FIELD INSPECTION REPORT

Project Name:	Mountain Valley Pipeline	Inspector:	Marshall Willis
Inspection Date:	Monday, May 11, 2020	Project Contact:	Brian Clauto, Cory Chalmers
Spread I: Franklin County	STA 14845+68 – 14928+52 ATWS 375/376/540/541/377	Weather:	Dry

Figure 2: STA 14854+75 – Bridge underlayment damaged at S-A7 crossing.

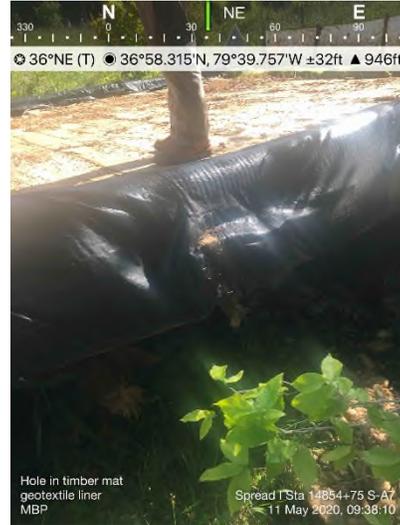
- STA 14853+40: Hole in bridge underlayment of S-H17 crossing. Repair needed.
- STA 14854+75: Hole in bridge underlayment of S-A7 crossing. Repair needed.
- STA 14901+00: End-treatment undermined. Repair needed.
- STA 14903+00: CFS at full capacity. Cleanout needed.
